CITY OF TACOMA
Public Work Engineering Division

ADDENDUM NO. 2

Request for Bids Specification No. PW20-0023F
Streets Initiative Package #22

SHEET C-5 OF C-18

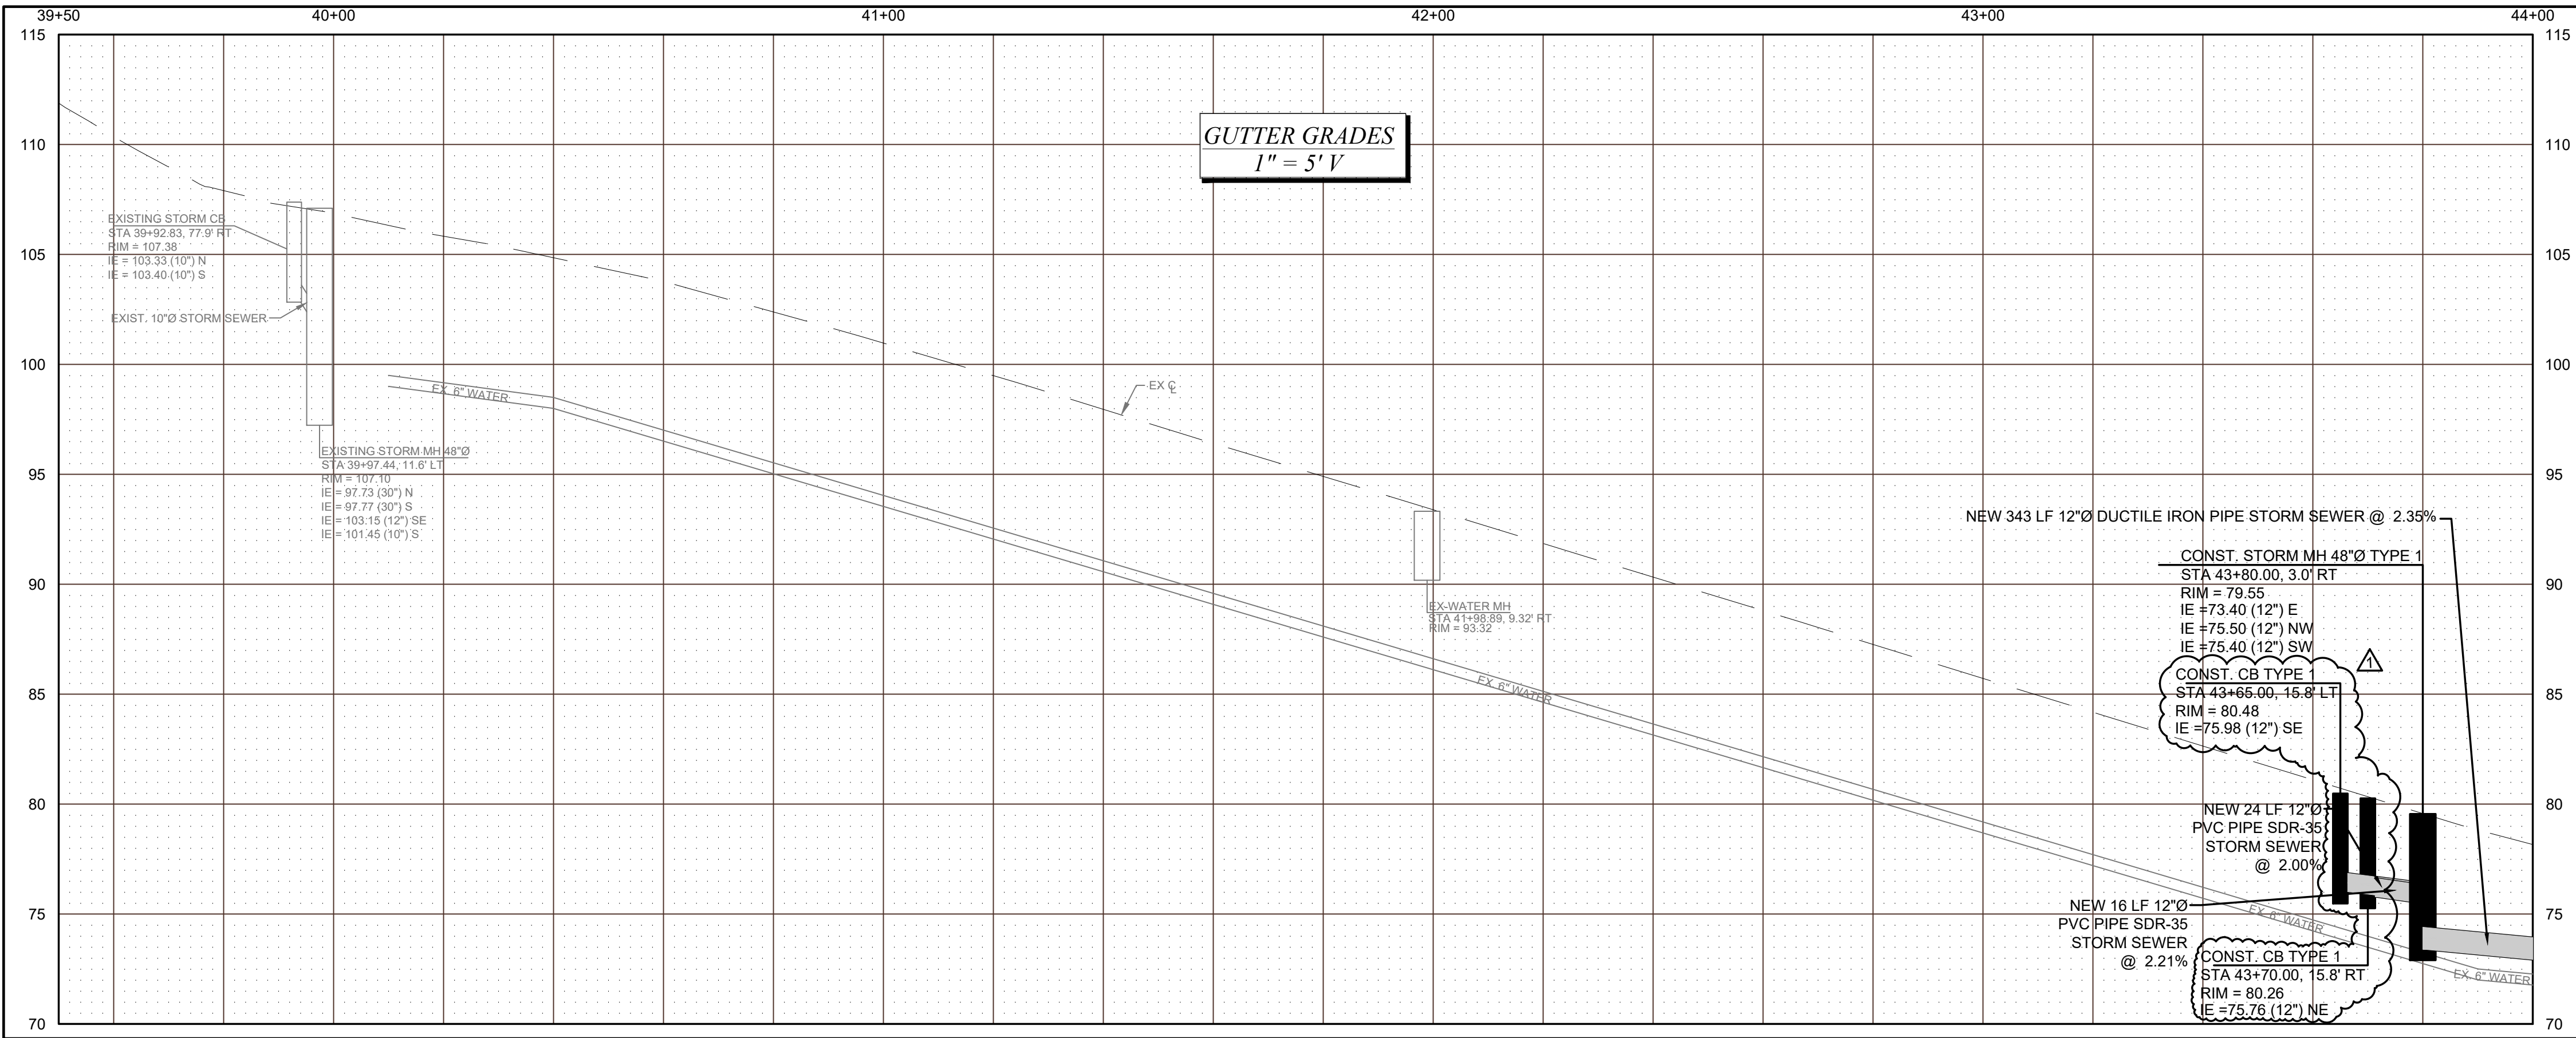
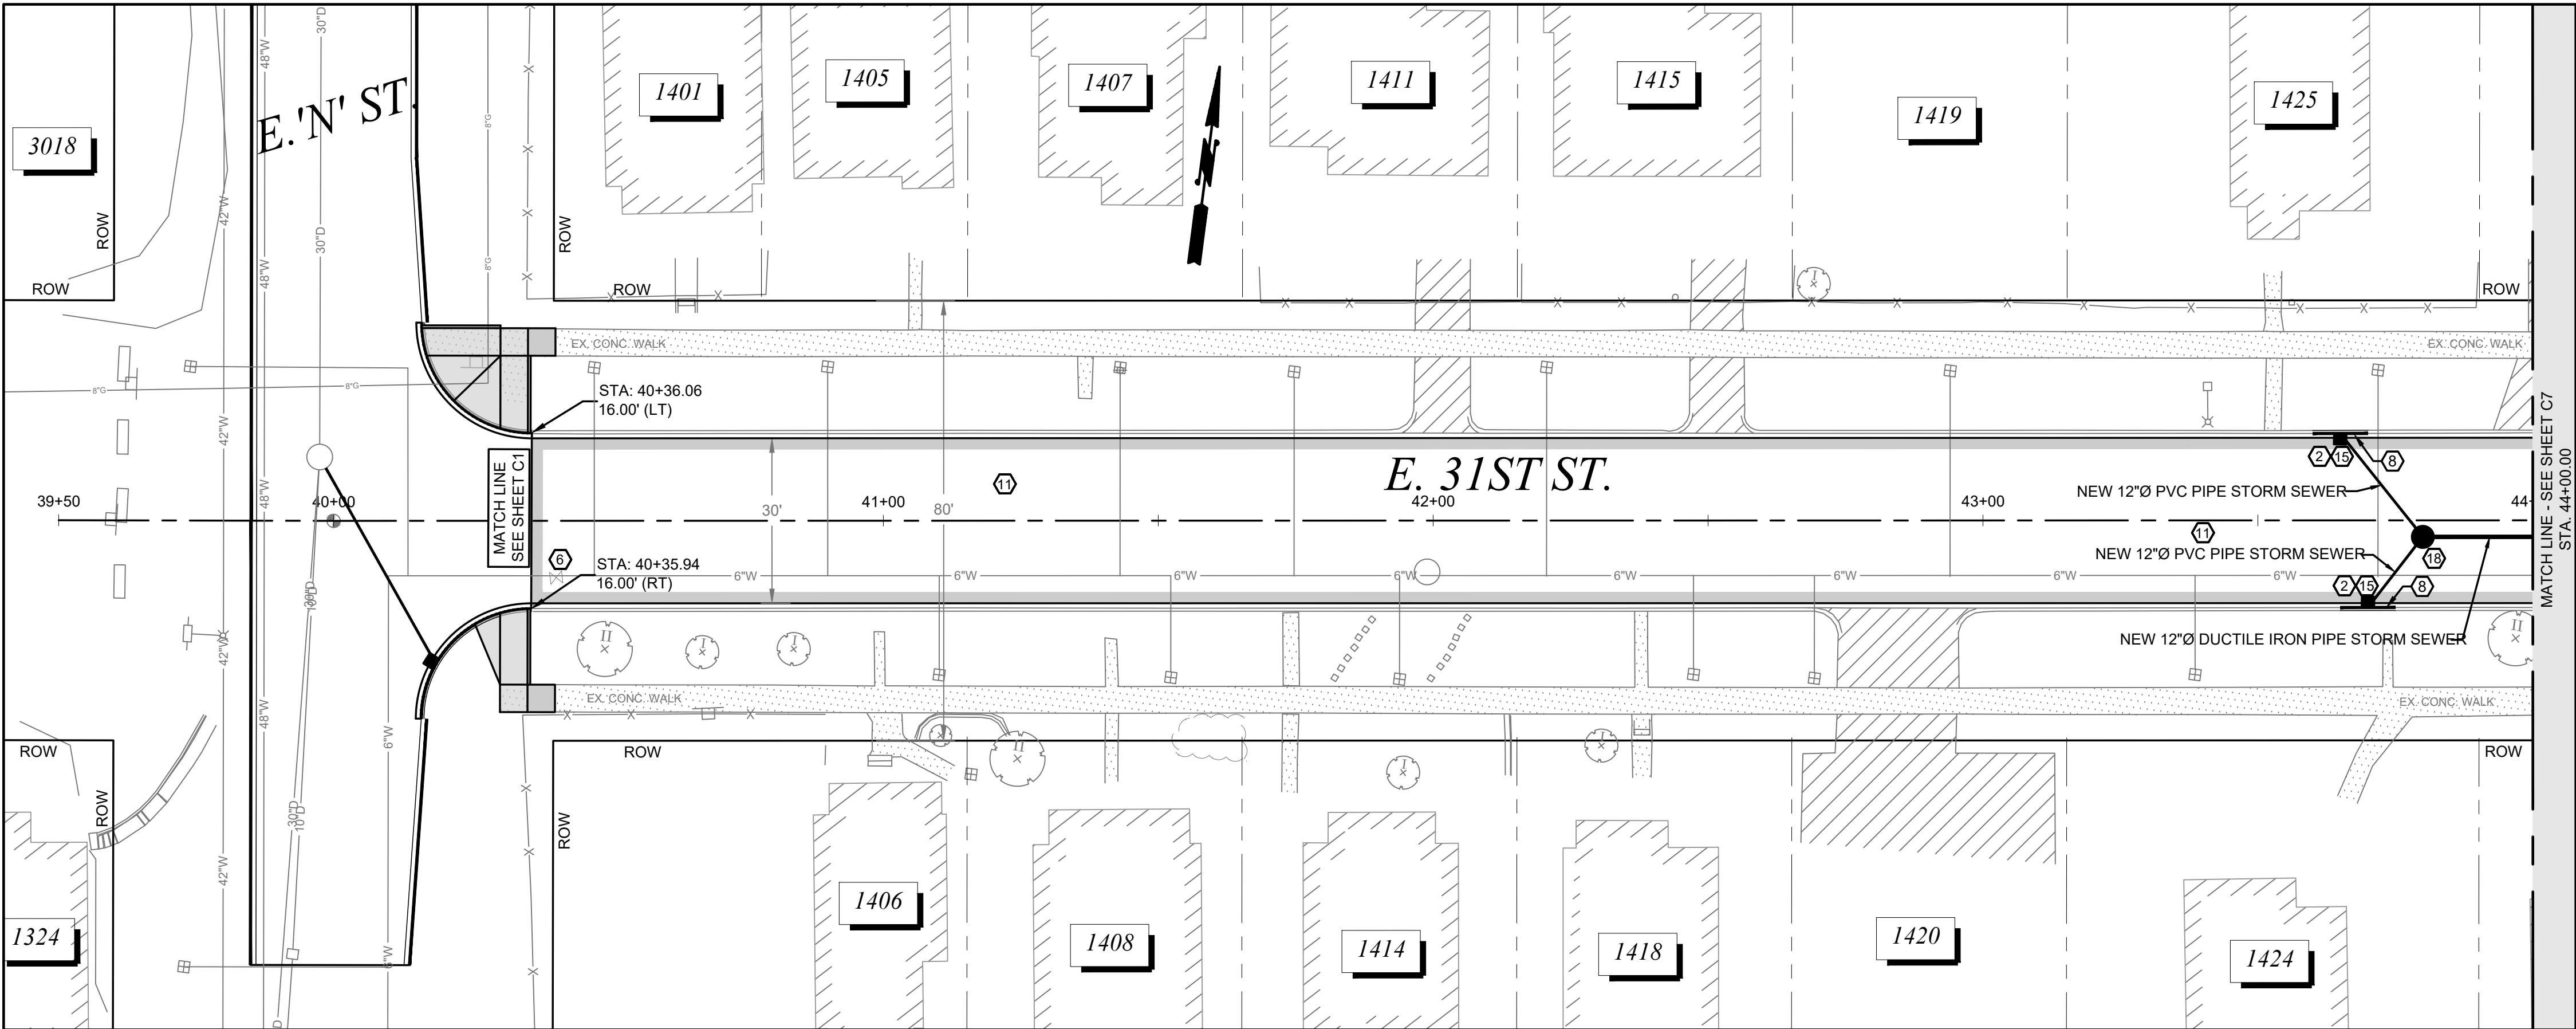
Q. The two CB Type 1 on sheet C-5 in the intersection, & the two CB Type 1 on sheet C-7 also in the intersection, & the two CB Type 1 on sheet C-10 in the intersection are not labeled vaned grate or combination inlet like the rest of them are. And since there is a large price difference between the two different castings can you please clarify which types these are please.

A. The City will issue new plan sheets to address this issue.

Replace plan sheet C-5 in its entirety and replace with the following attached labeled Addendum #2.

PWK-00434-22
SHEET NO.
SHEET C-7 OF C-18

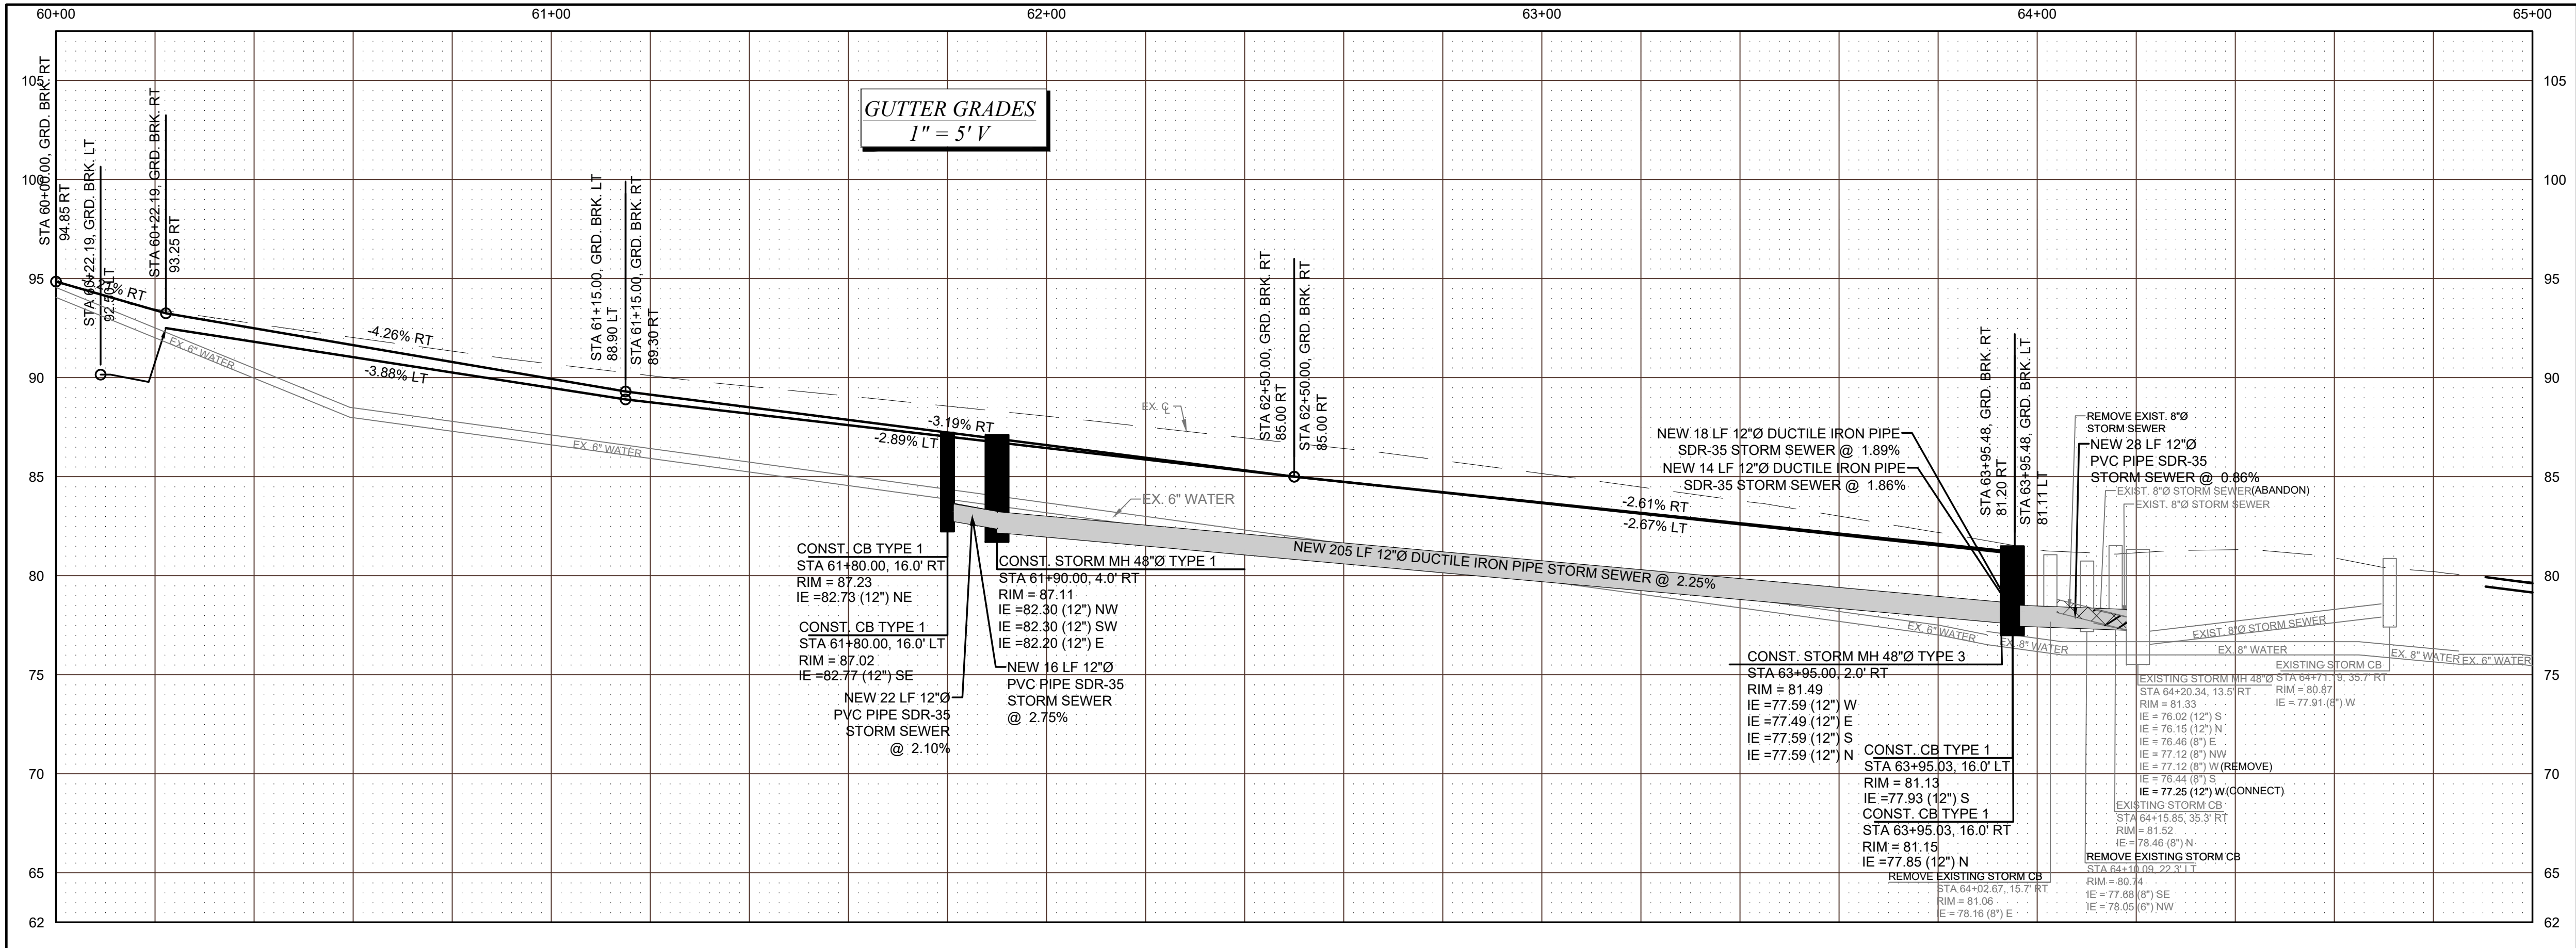
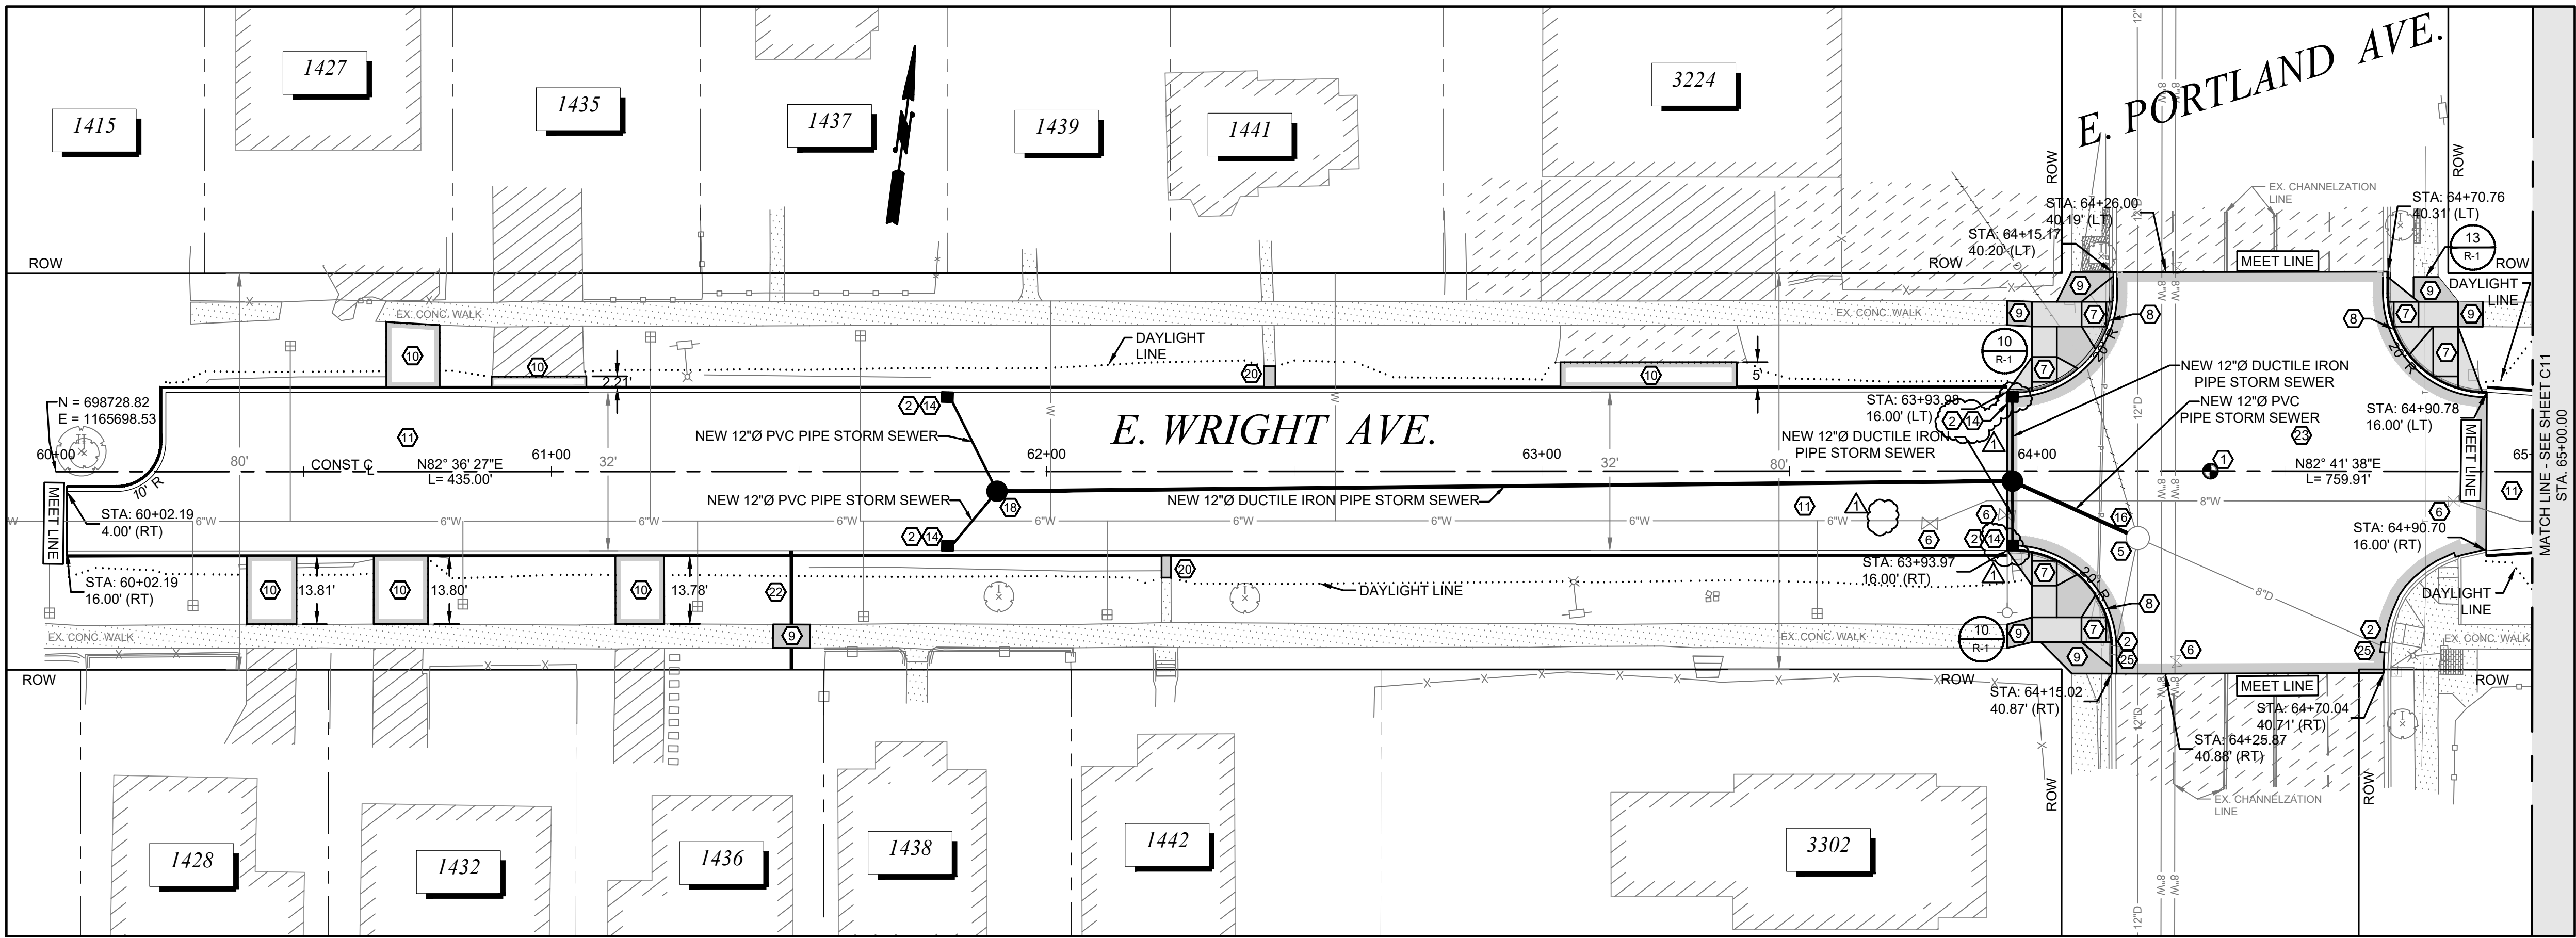
Q. Bid item No. R30 is for 8 each Manhole 48 in. diam. Type 1, Bid item No. R31 is for 2 each Manhole 48 in. diam. Type 3. Yet on the plans all 10 Manhole 48 in. diam. Are called out as type 1 in the profile. In the construction notes you don't even have a call out for a Type 3 manhole.

A. The two type 3 manholes are labeled in the profile view. One on sheet C-10, the other is on sheet C-7 for which the City will issue a new plan sheet

Replace plan sheet C-7 in its entirety and replace with the following attached labeled Addendum #2.
